Re: Revised Supplemental Interim Measures Work Plan
Solutia Inc. Anniston, AL Facility
EPA ID No. ALD 004 019 048

**SUPPLEMENTAL
INTERIM MEASURES WORK PLAN**

16.0	43	1	44	45	2	0	2	47	11	58	60	0	1	0	0	0	0	2	
16.5	38	1	39	40	1	0	1	41	10	51	53	0	1	0	0	0	0	1	
17.0	35	1	36	36	1	0	1	37	9	46	47	0	1	0	0	0	0	1	
17.5	33	1	34	34	1	0	1	35	9	44	44	0	1	0	0	0	0	1

TITLE		AREA DRAINAGE			
DRAWN	RJS	DATE	5/98	JOB NO.	963-8294
CHECKED		SCALE	AS SHOWN	DWG. NO.	REV. NO.
REVIEWED		FILE NO.	943-3680	SUBTITLE	FIGURE NO. 3

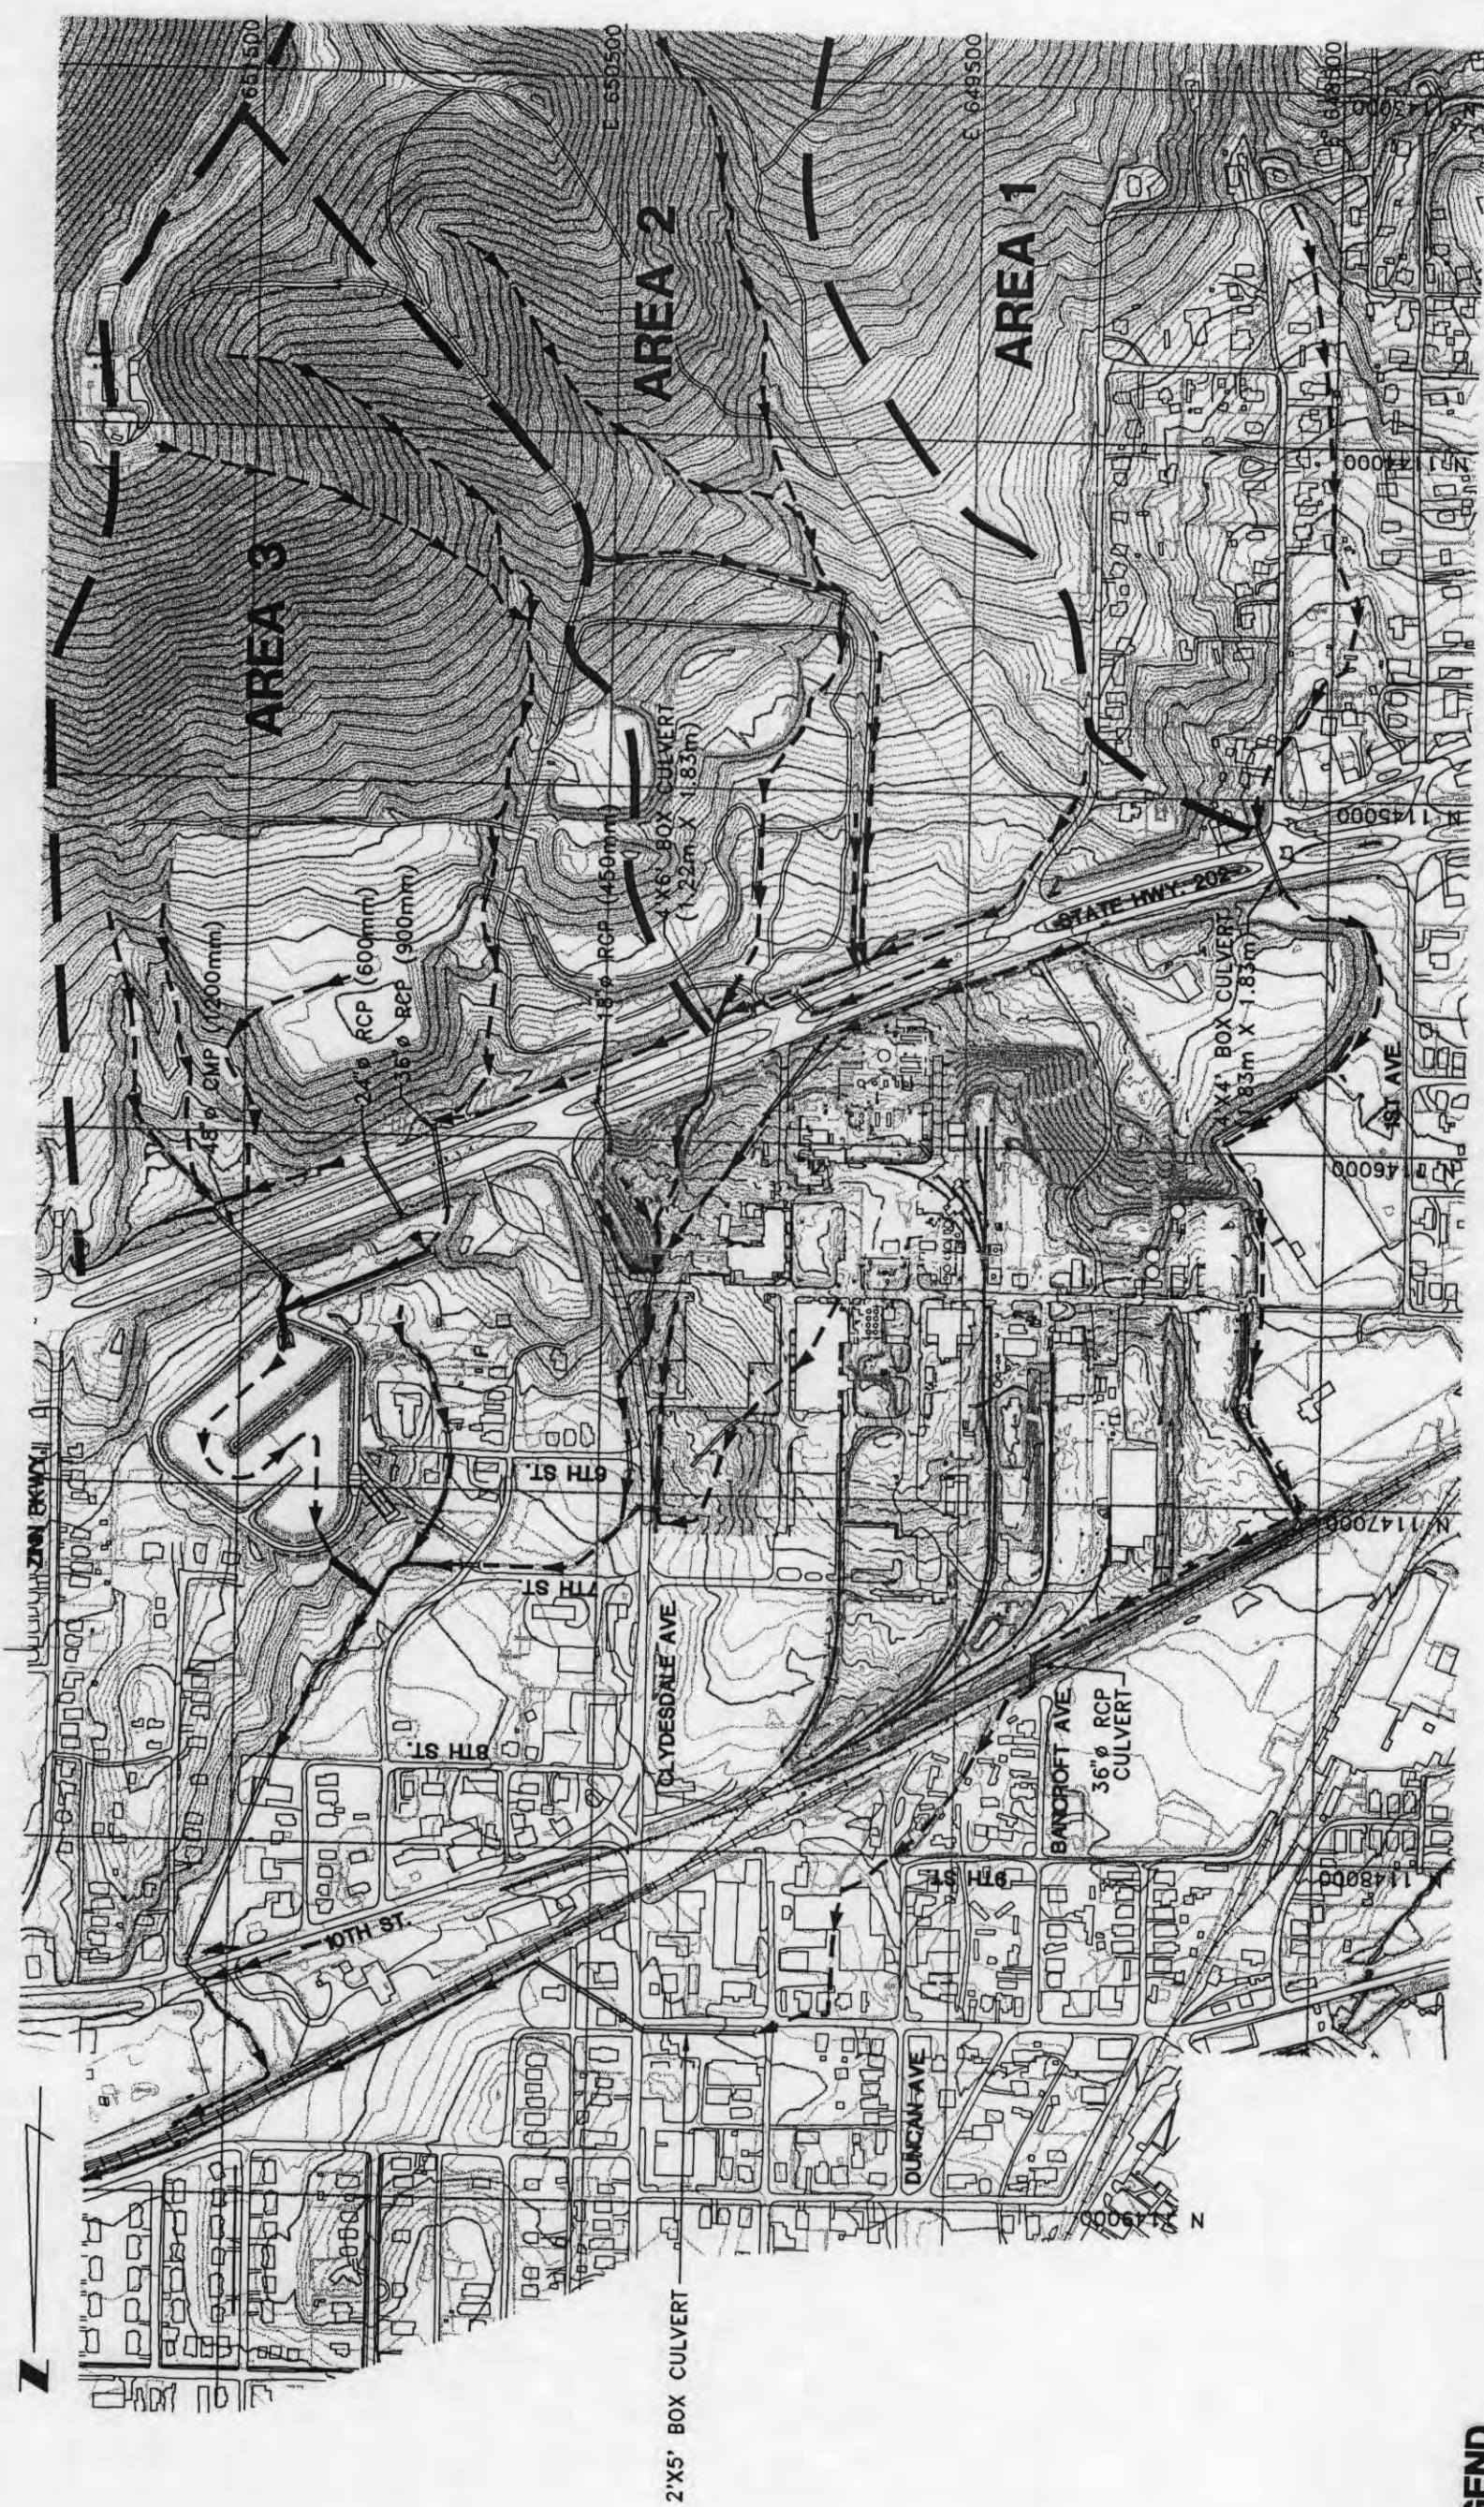
1. **Section 2, Second Paragraph and Attached Drawings SK-2:** The Workplan text describes specific drainage basins and major stormwater conveyances that are the subject of the Supplemental Work Plan. However, the drainage basin/divides and major conveyances (culverts, DSN 008, open channels and swales) are not depicted on the drawings. This information should be included on the figures, as well as being described in detail in the text. This applies to the drainage basin south of the railroad tracks as well as the drainage basin(s) that comprise the proposed pipeline area and capped contamination area.

Figure 3 has been added to the Work Plan. This Figure shows the requested information. As well, the text has been revised to more fully describe the various drainage basins.

PERFORATED SECONDARY INLET STRUCTURE
1/2" = 1'-0"

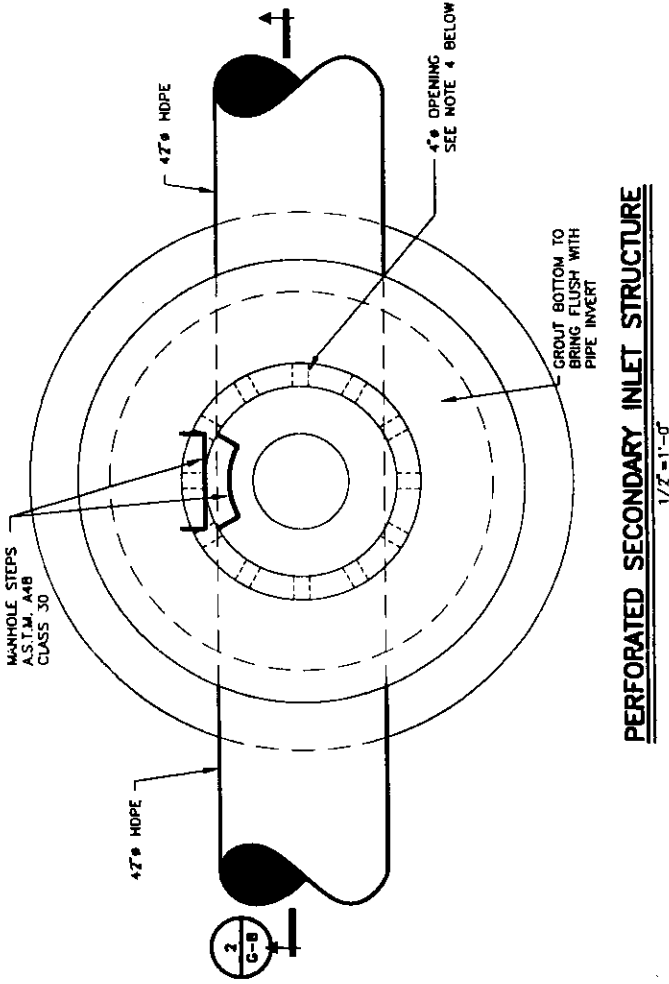
11. **Perforated Inlet Structure:** The operation of the perforated secondary inlet structure is unclear. What are the perforations for and what do they look like? Is it a cast in-place manhole with perforations at the top cover?

Details of the Perforated Secondary Inlet Structure are shown on Sheet G-9 in Attachment 2. The structure is a standard precast 8 ft. diameter manhole with a 4 ft. diameter riser. The perforations are 4 in. diameter holes. The structure will function as both an inlet and outlet, allowing ponded water to drain into the 42 in. diameter pipe during off-peak flow and allowing surcharge flow to backup into the impoundment during peak flow periods.
